FERC Compliance Order on DER Aggregation: Review and Initial Thoughts

PJM Staff

May 8, 2023

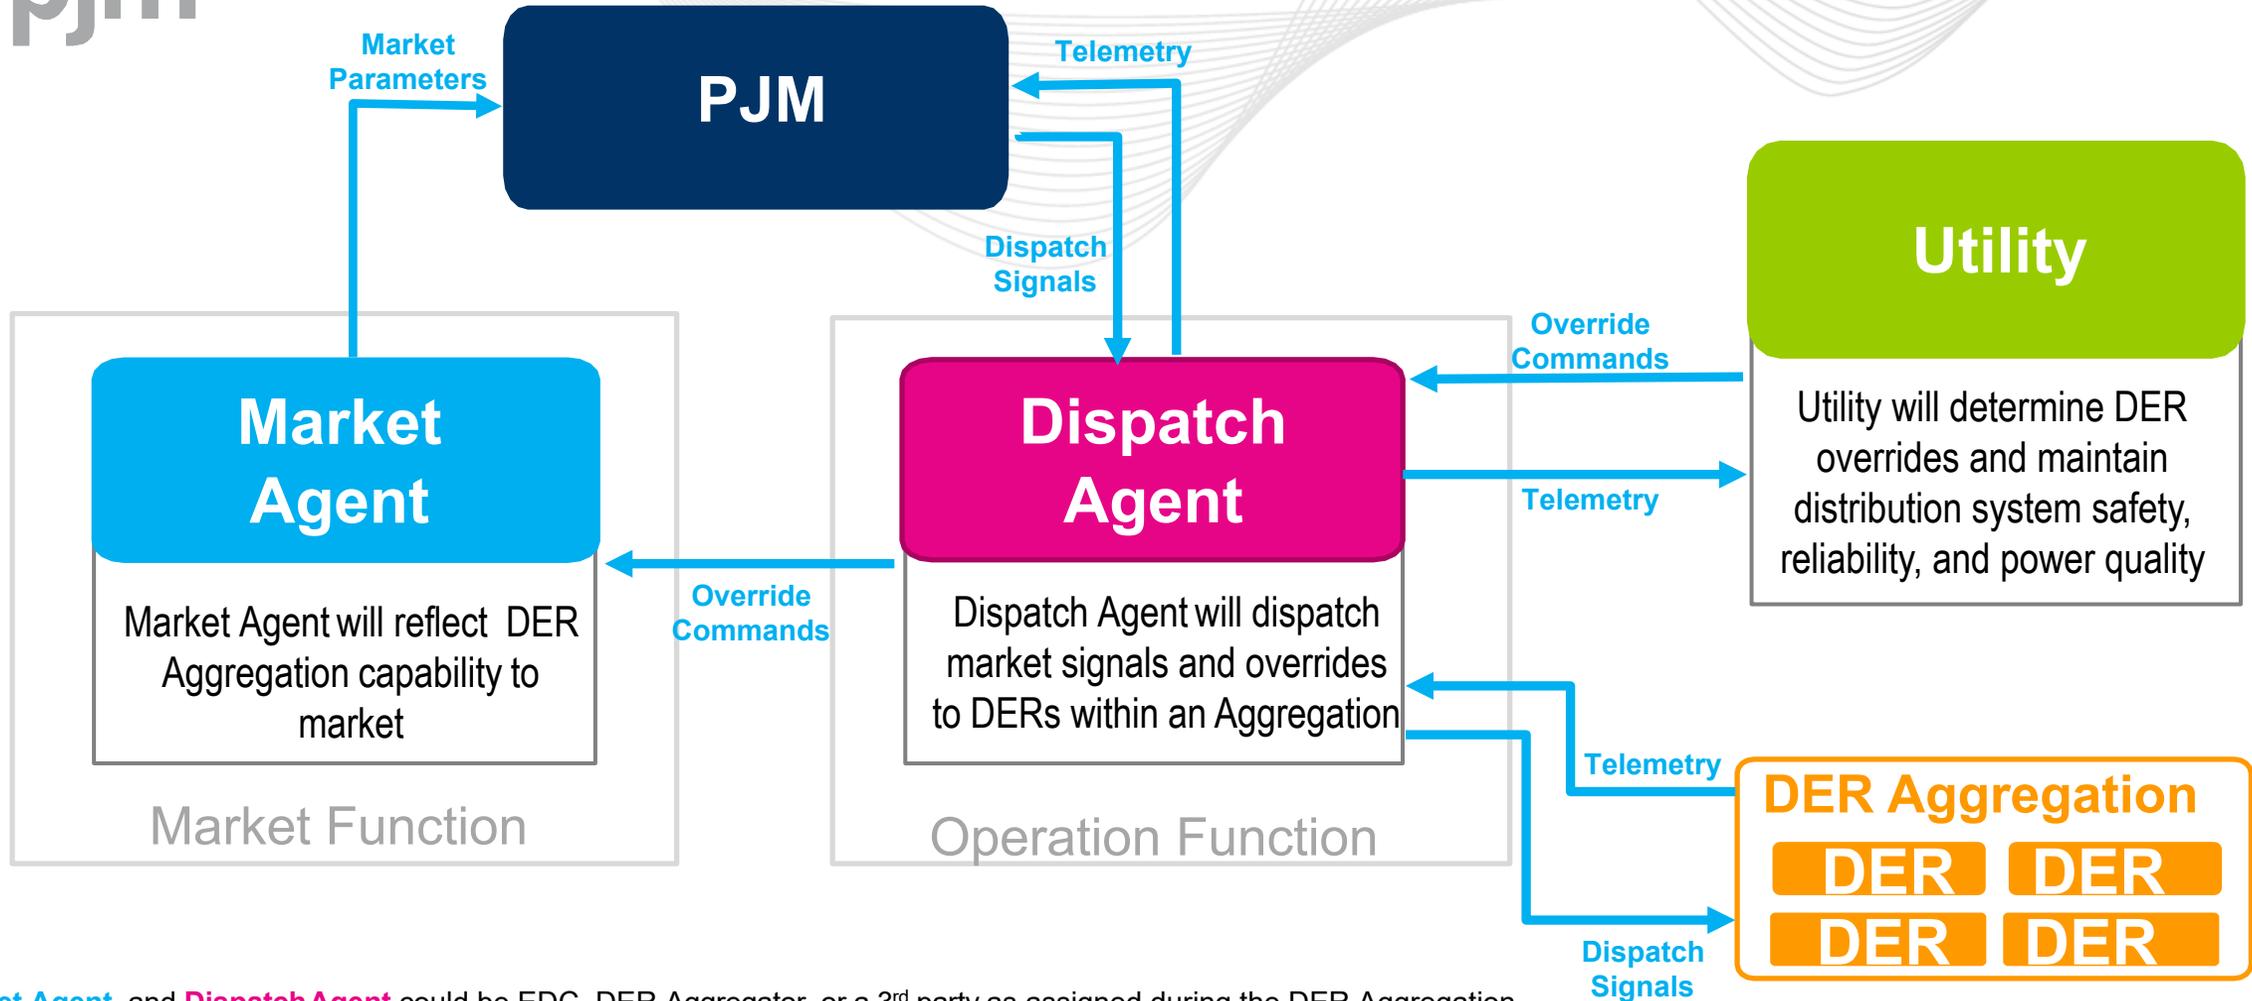
- Pg 222: Second, PJM’s proposed tariff language requiring the DER Aggregator to provide **“associated physical and transmission system electrical location information of the applicable Component DER” is also unclear.** While we believe that PJM has generally explained the need for this electrical location information, in that it enables PJM to map the Component DER participating in a DER Aggregation Resource to an individual node, **PJM has not identified the specific information that the DER Aggregator is required to provide.** Therefore, we find that PJM must identify what specific information it requires related to the physical and transmission system electrical location of the Component DER and explain why the specific information is necessary, consistent with Order No. 2222.

- DER Aggregator needs to provide the physical address associated with the Component DER
- The EDC, not the Aggregator, will provide the PJM Planning Model (PSS/E) bus ID(s) that the distribution circuit associated with the Component DER is fed from; if multiple bus IDs, provide weighting factor (%)
